# UNITED STATES PATENT AND TRADEMARK OFFICE

10/803,359

## Office Action Summary

### **DETAILED ACTION**

Fig. 1

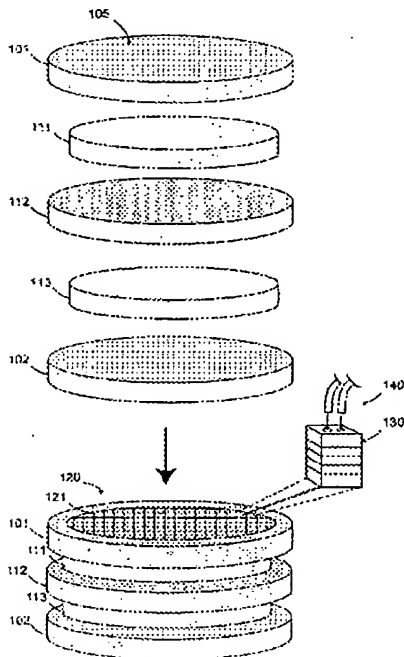
second] optical fiber Please refer to Fig. 1 where Jian teaches the stack of semiconductor wafers

with a die within the array of dice that form the stack (130).

The applicant does not explicitly and positively claim that the graded index structure is formed immediately at the

distal end of the fiber. Since the optical devices in Jian's teaching forms a continuous stack, then Jian's teaching

reads upon applicant's claimed limitation of "formed

Fig. 6

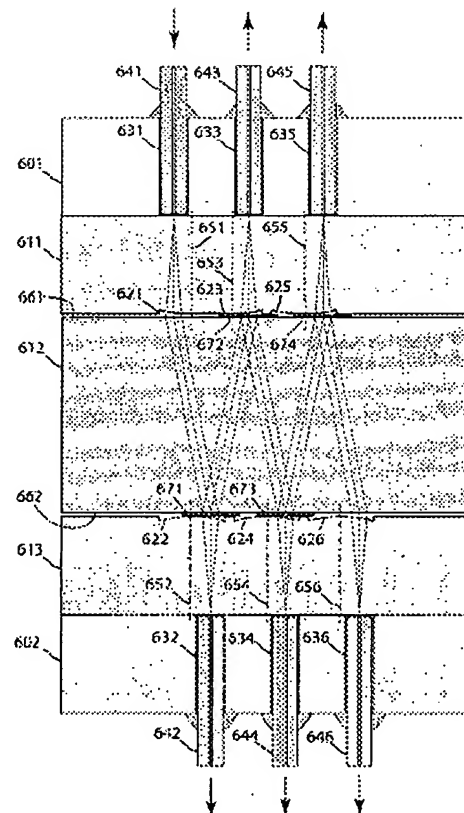
Regarding claims 1, 2, and 8, Jian teaches an optical monitor module comprising a substrate in Figure 6 having formed on the upper surface a positioning structure, namely an array of v-grooves [0154] and reference numbers 631, 633, 635 for positioning a plurality of optical fibers 641, 643 in parallel. The first and second optical fibers having formed integrally therewith at the same end lens portions 621. For clarification purpose, the examiner will further explain how Jian teaches the graded index structure is "formed integrally in one end of the [first and

integrally in one end of the... fiber." A beam splitter (612)

mounted on

said substrate

at a position

between an

extension of said axis of the first fiber and an

extension of the axis of the second fiber for

receiving light emitted from said lens portion

(621) of said first optical fiber and for reflecting

the other portions of said light for incidences on

said lens portion (623) of said second optical fiber

(643); wherein the optical paths between said lens

portions of said first and second optical fibers and

said beam splitter are spaced. Please trace the

light ray for further clarification.

Regarding claims 6 and 7, the line of intersection wherein the ray transmitted from the lens of the first fiber and the lens of the second fiber intersect near a straight line centrally extending intermediately between and the elongations of the first and second optical fiber. A simple ray trace and a drawn imaginary line between the fibers 641 and 643 of Figure 6 will clearly teach this limitation.

Regarding claims 6 and 7, the beams intersect upon the incidence at elements 671 and 673 and the incident point is the midpoint between the optical axes of the first fiber (641) and the second fiber (643).
